# UNITED STATES PATENT AND TRADEMARK OFFICE

APPLICATION NO.	FILING DATE	FIRST NAMED INVENTOR	ATTORNEY DOCKET NO.	CONFIRMATION NO.
09/420,965	10/20/1999	ELLEN M. HEATH	1074.010US1	3488

**Office Action Summary**

## **DETAILED ACTION**

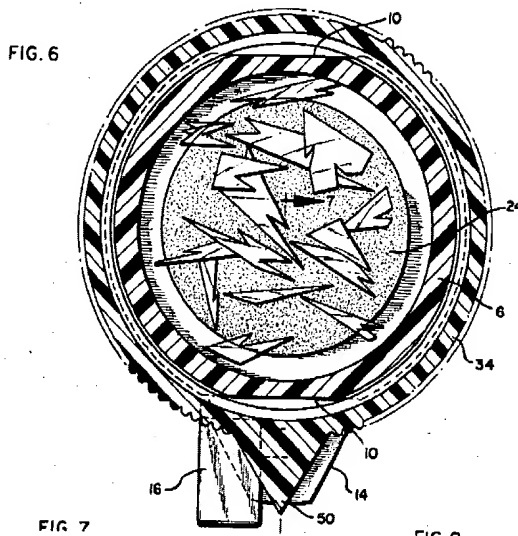
As to the cap and vessel flange being the same shape, the examiner clearly pointed out the equivalent elements in that of the device of Konefal et al. Complimentary elements 54 and 44 or the cap and vessel are considered flanges for it is clear that the elements are substantially the same shape and are aligned when the cap is attached to the vessel.
